STANSTED AIRSPACE

Proposal for Implementation of a Transponder Mandatory Zone

Response from Saxon Microlights

Figure 1: proposed alternative boundary to section D of proposed TMZ

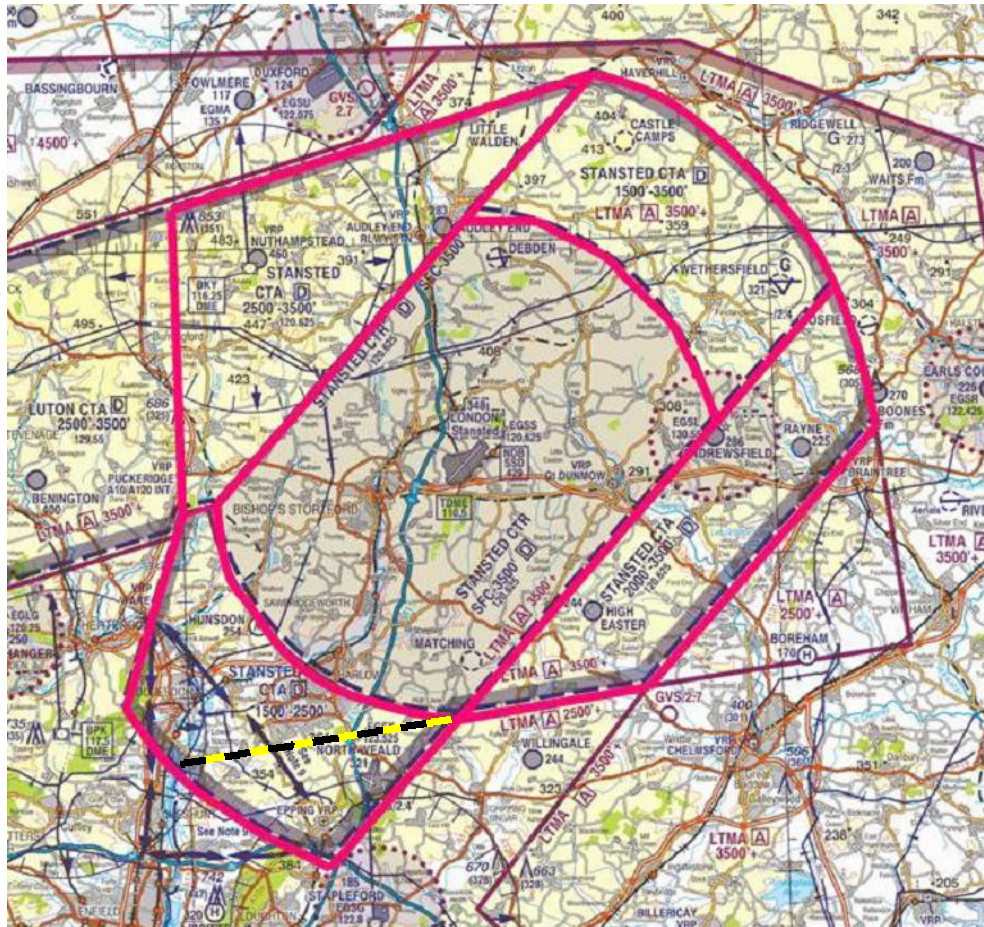
Saxon Microlights preferred outcome is that no TMZ is imposed, but if one is imposed that it has the minimum dimensions possible. We would propose a variation on the option two (sections B and D only) whereby the southern edge of section D of the proposed TMZ be drawn as a continuation of the southern edge of proposed section C as illustrated in figure 1 below. This is similar to the segment already absent from northern edge of section D. Although of no significant benefit to Saxon Microlights, a similar segment excluded from the southern portion of section B would no doubt benefit the glider operations at Wethersfield.
